Section 4.55(2) Modification Application to DA-2/2025

42A Beale Street, Georges Hall NSW 2198

2.1 Hydrant Booster System

Figure 1: Proposed location of the new hydrant booster system

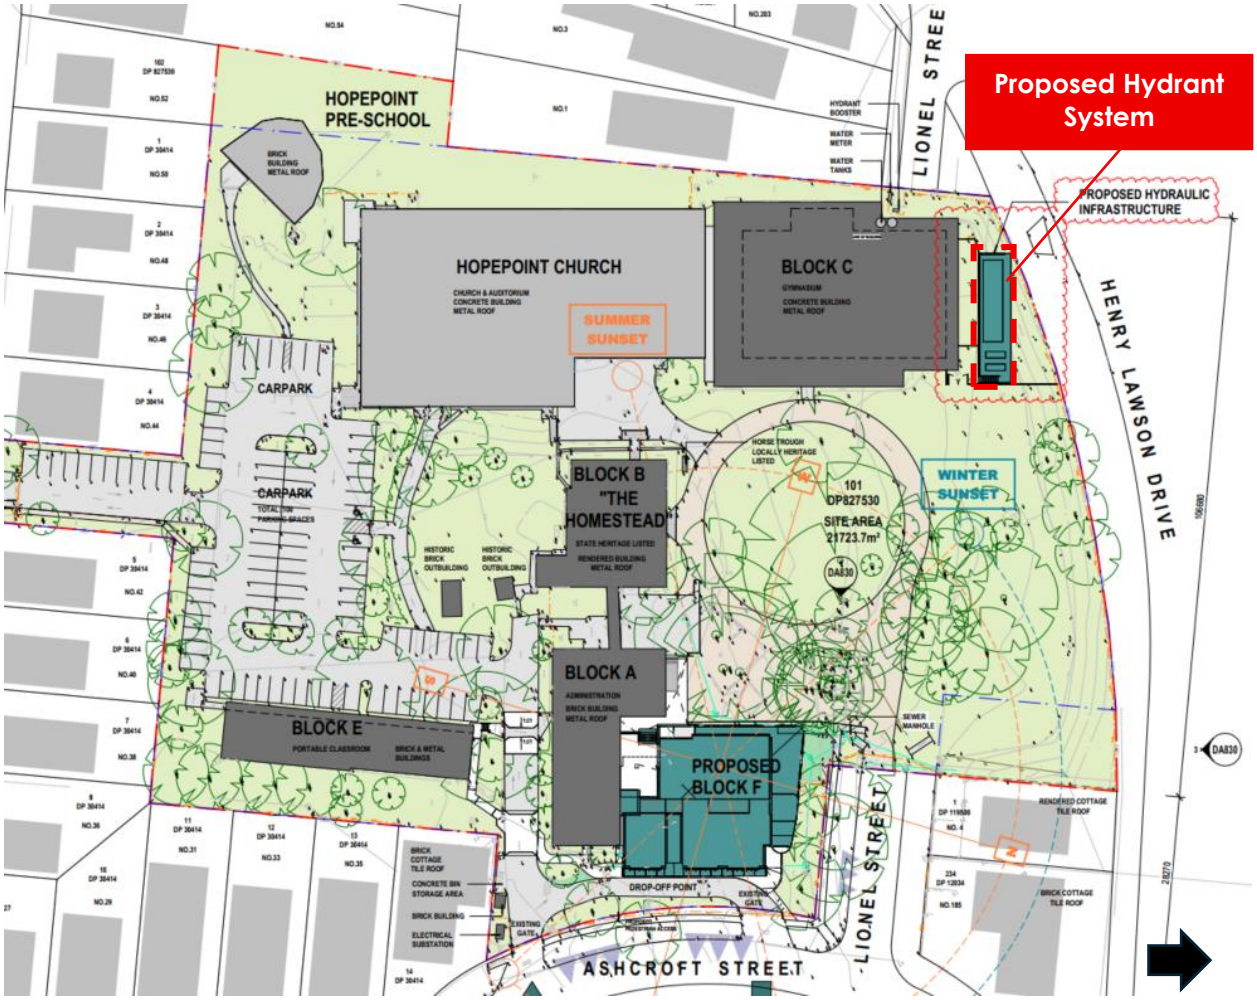
The proposal seeks to include the installation of a new hydrant booster system and associated works to the Consent. The new infrastructure is located to the north west corner of the site, fronting Henry Lawson Drive and north of Block C (**Figure 1**). The works will involve:

- Earthworks to create a building pad for the hydrant system, construction of retaining walls and stormwater connection, and
- Installation of a 90,000L tank with two pump systems and connection to the existing booster valve.

The proposed hydrant booster is required to ensure compliance with the relevant hydrant performance requirements under the Building Code of Australia (**BCA**) / National Construction Code (**NCC**), noting that the scale of the approved development is greater than originally anticipated. The inclusion of the hydrant booster will ensure adequate fire-fighting water pressure and flow are achieved across the site in accordance with the relevant Australian Standards.

Figure 2: Proposed hydrant

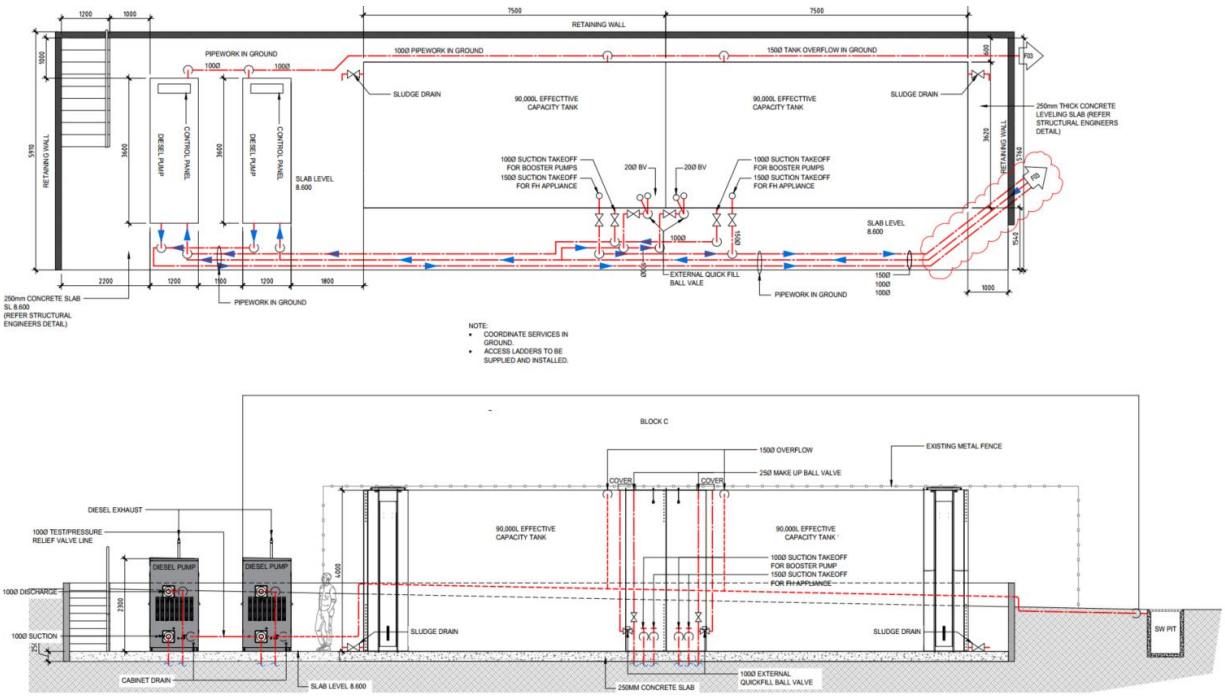
An Arboricultural Assessment has been prepared to assess whether the proposed hydrant system will impact trees within the vicinity of the works. The assessment confirms that the proposal will not require the removal of any trees. However, specific tree protection measures are recommended, including the installation of ground protection mats around Trees 14 to ensure no works occur within their structural root zones, as well as the provision of tree protection fencing around surrounding trees.
